ADDENDUM #4

TO: BIDDER
FROM: ANDRE-ANNE CHENAILLE
SUBJECT: WHITMAN ROAD CULVERT REPLACEMENT PROJECT
DATE: 6 MAY 2026
CC: TOWN OF HANCOCK

Whitman Road Culvert Replacement Project

PROPOSED CULVERT
HANCOCK
WHITMAN ROAD
OVER KINDERHOOK CREEK
MASSACHUSETTS DEPARTMENT OF TRANSPORTATION
HIGHWAY DIVISION
10 PARK PLAZA BOSTON, MASS
SHEET C1-TITLE SHEET

3 Temporary Sandbag Cofferdam Detail
C4 Not to Scale

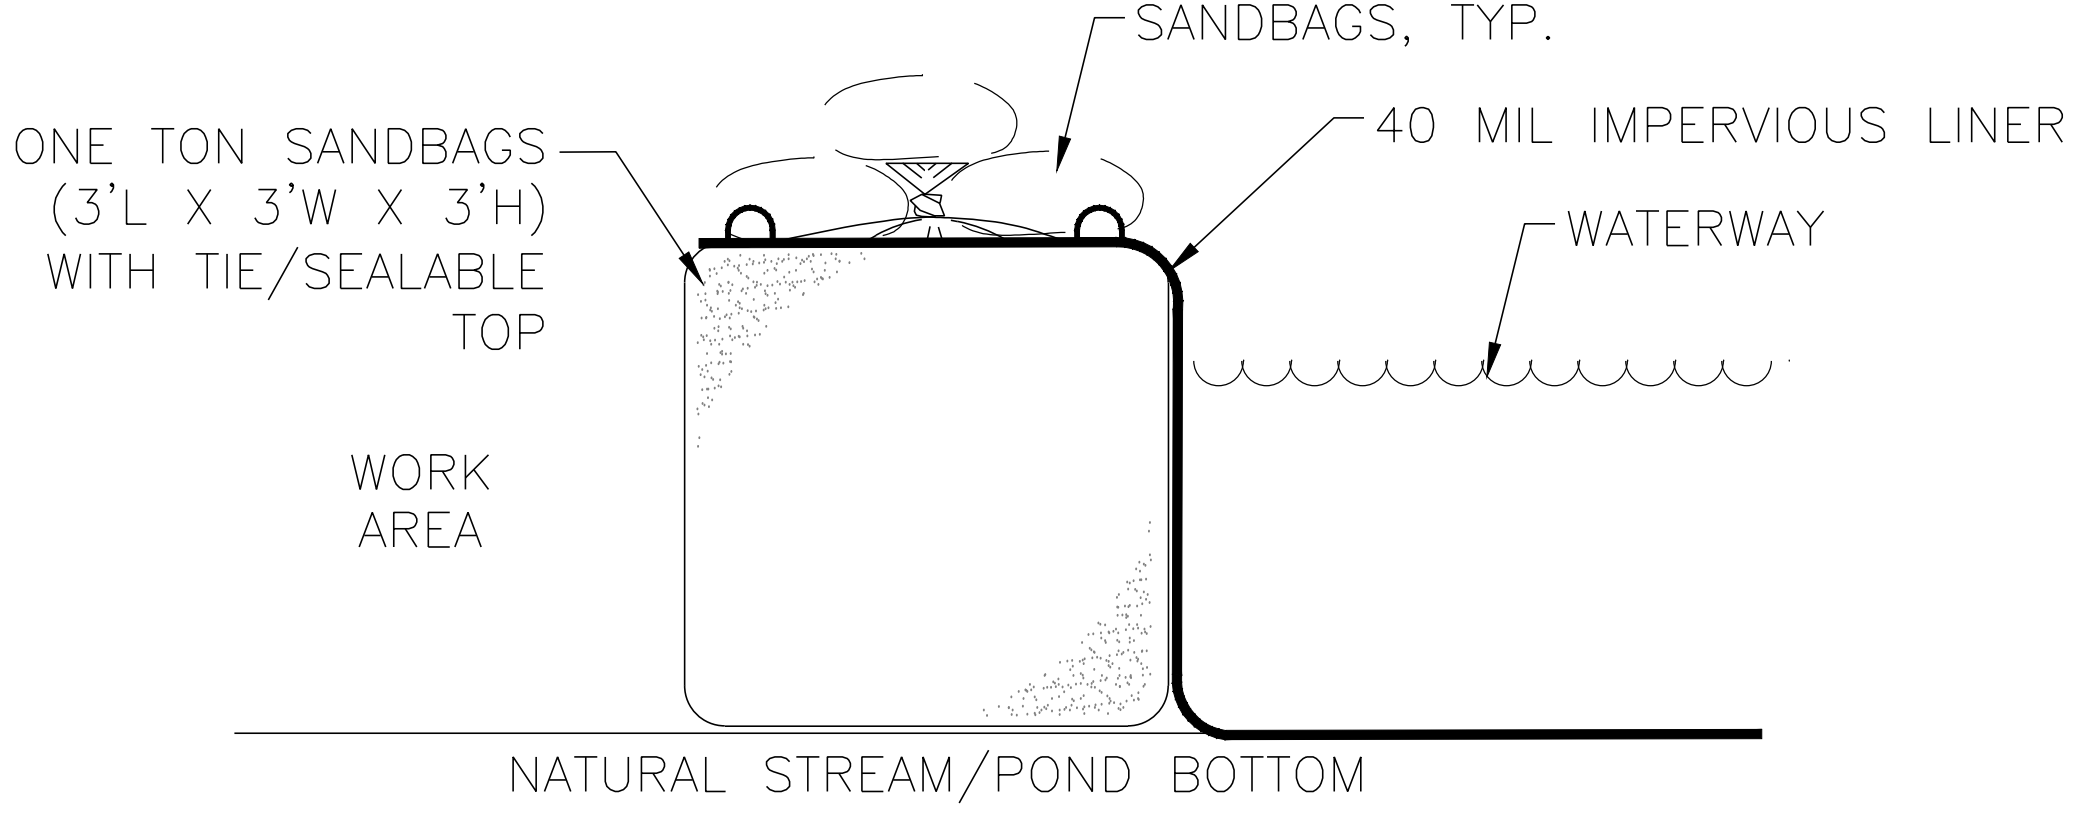
3) Sheet 4 has been revised to include more information regarding control of water. It should be clarified that the Contractor shall be responsible for the design of the control of water system. The control of water system shown is conceptual only as one option for control of water. The Contractor shall determine the appropriate system for controlling the water (i.e. bulk sandbags, sheeting, etc.) and shall submit a control of water plan to the engineer for approval.

1. THE CONTRACTOR SHALL BE RESPONSIBLE FOR THE DESIGN OF THE CONTROL OF WATER (C.O.W.) SYSTEM. THE C.O.W. SYSTEM SHOWN IS CONCEPTUAL ONLY AS ONE OPTION FOR CONTROL OF WATER. THE CONTRACTOR SHALL DETERMINE THE APPROPRIATE SYSTEM FOR CONTROLLING THE WATER (I.E. BULK SANDBAGS, SHEETING, ETC.) AND SHALL SUBMIT A C.O.W. PLAN TO THE ENGINEER FOR APPROVAL.
2. C.O.W. SYSTEM SHALL BE INSPECTED DAILY FOR WATER LEAKS OR EROSION AND REPAIRS PROCEDURES SHALL BE IMPLEMENTED ACCORDINGLY.

1 Culvert Replacement Plan
 C5 1" = 20'

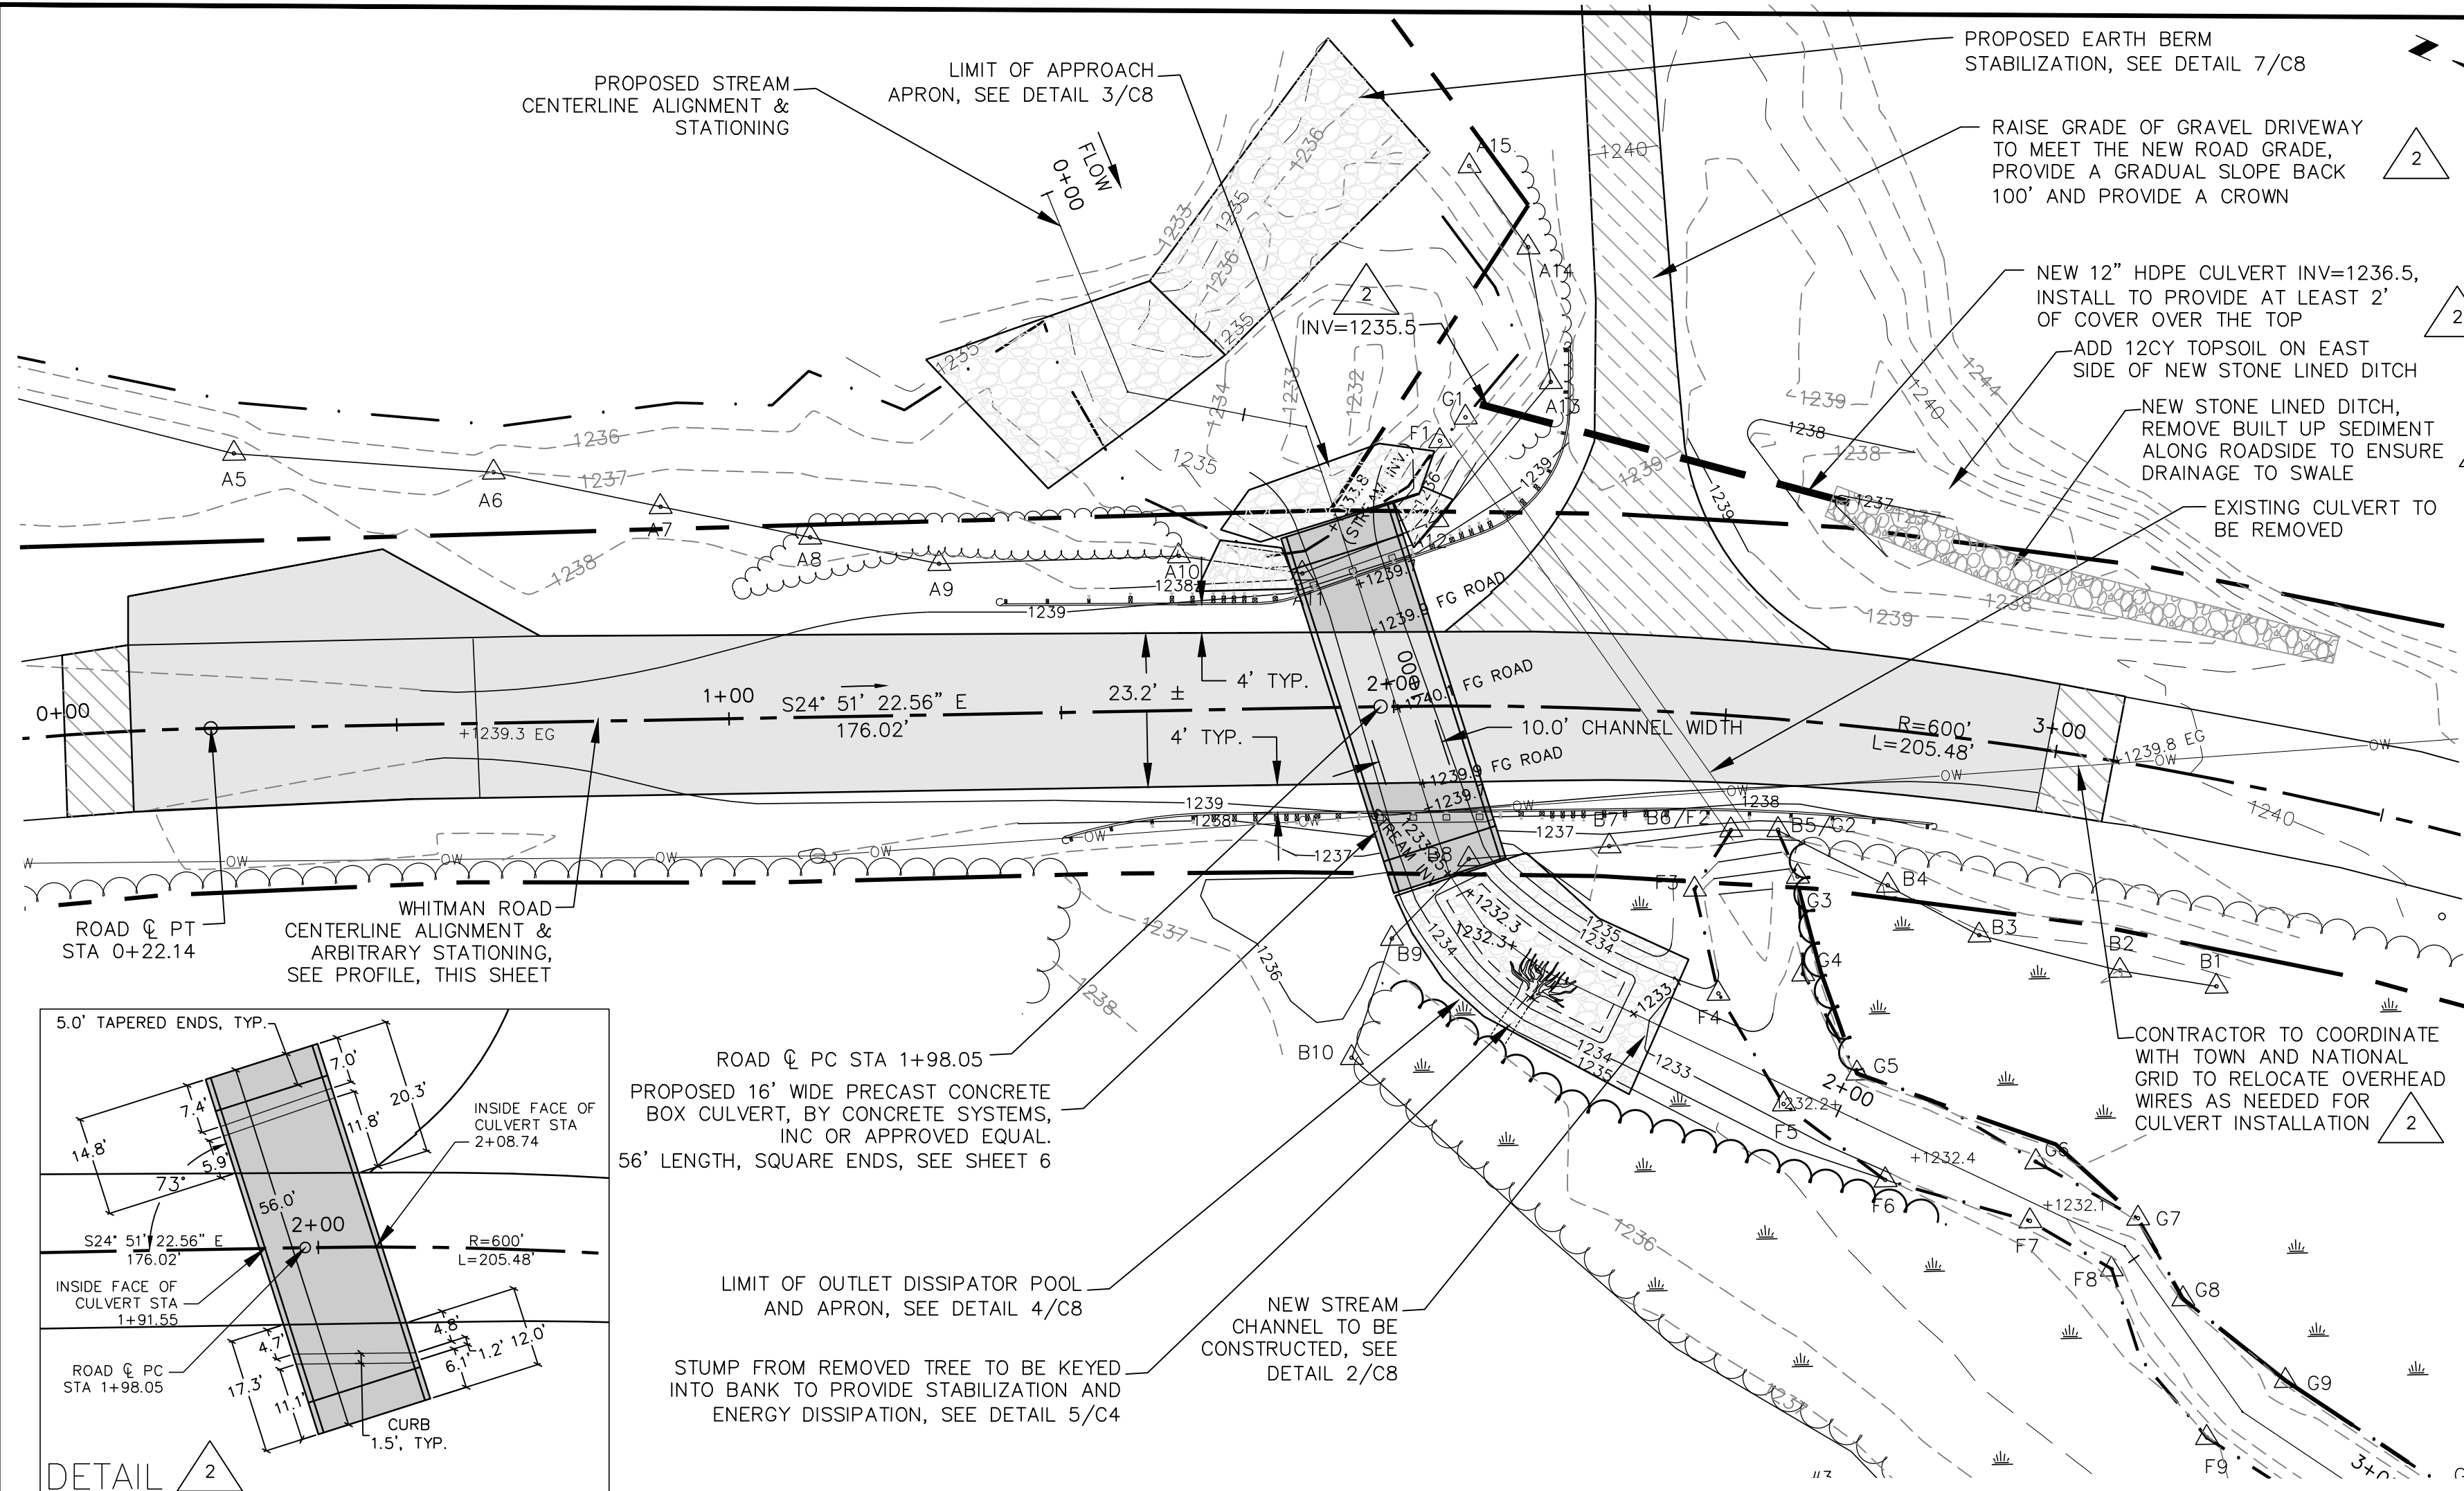
1) A stone-lined ditch has been added to the project scope (Sheet 5) along the existing gravel driveway to the southeast of the proposed culvert. This scope includes earth reshaping to create the swale, installation of stone, and ensuring the ditch drains to the proposed 12" HDPE culvert. Additionally, the contractor shall plan to add 12 CY of topsoil to the east side of the stone lined ditch. A stone-lined ditch detail has been added to Sheet 10.

2) The proposed 12" HDPE culvert under the same gravel driveway has been slightly relocated to be closer to the road right-of-way. A note has been added to install the culvert to provide at least 2 feet of cover over the top.

4 Culvert Cross Section
 C5 1" = 2'

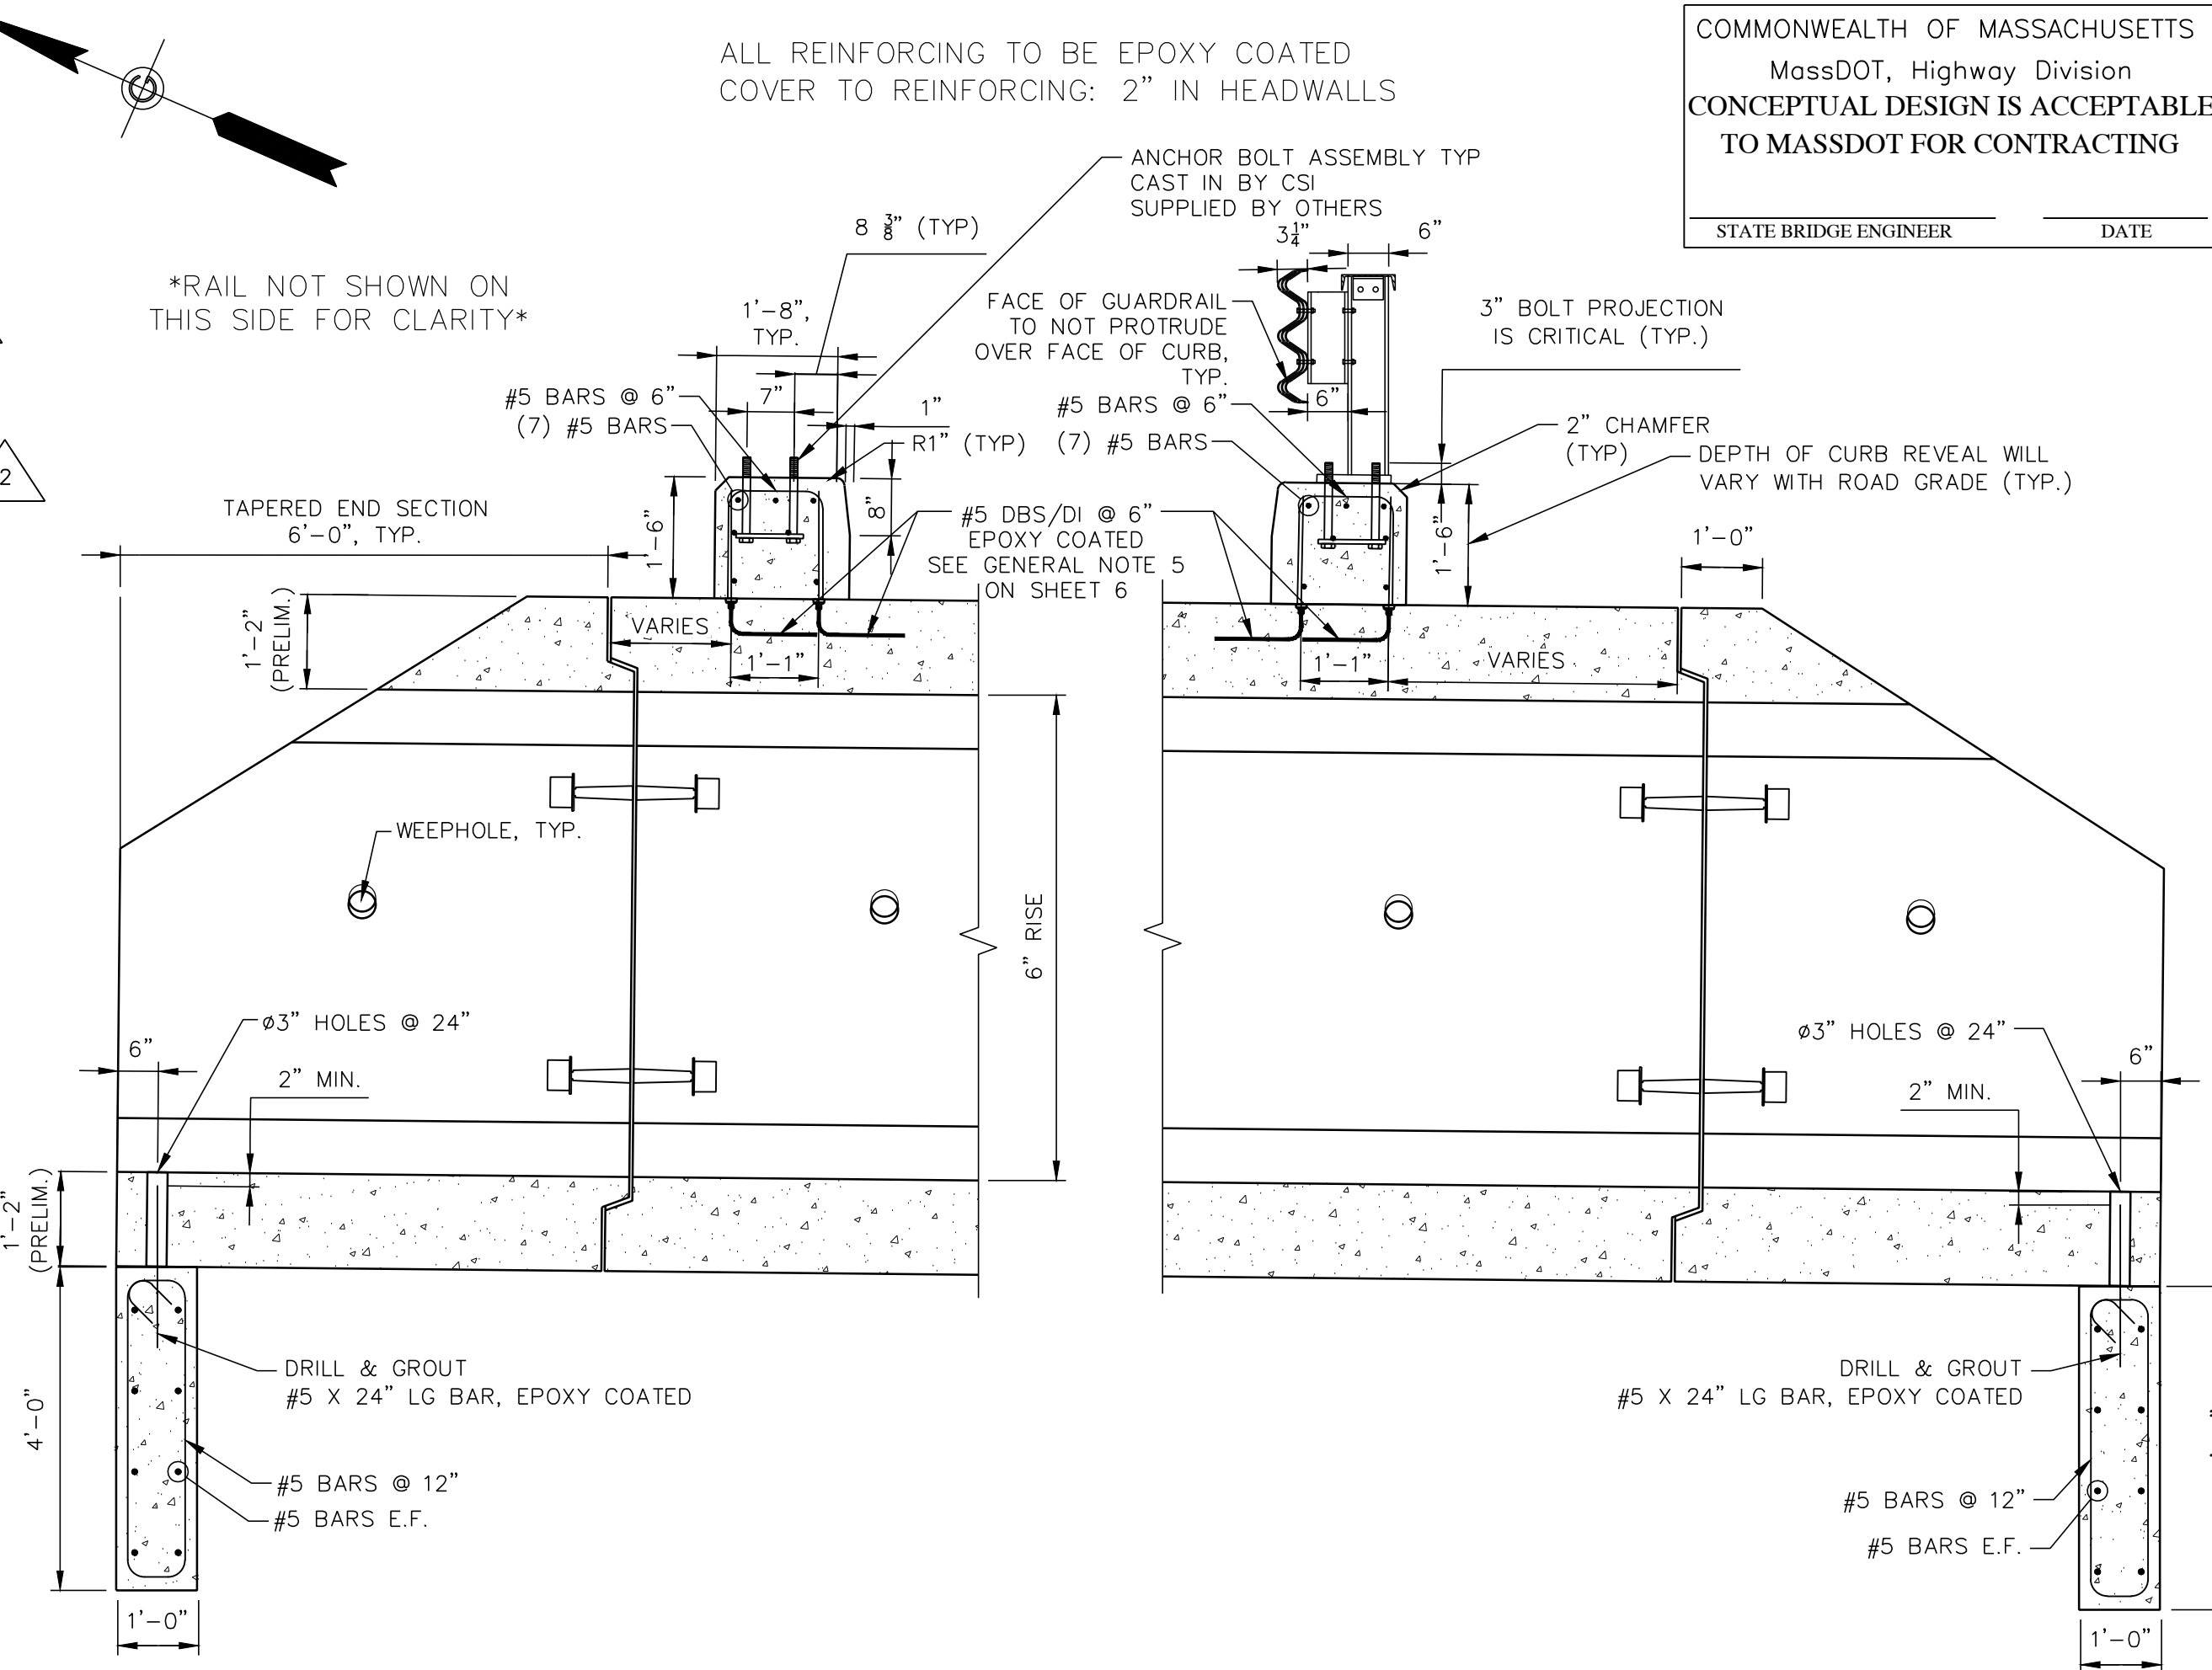
4) The precast concrete curb which will carry the bridge rail across the culvert has been widened by 2" for a total width of 1'-8" to ensure the guardrail does not protrude over the curb.
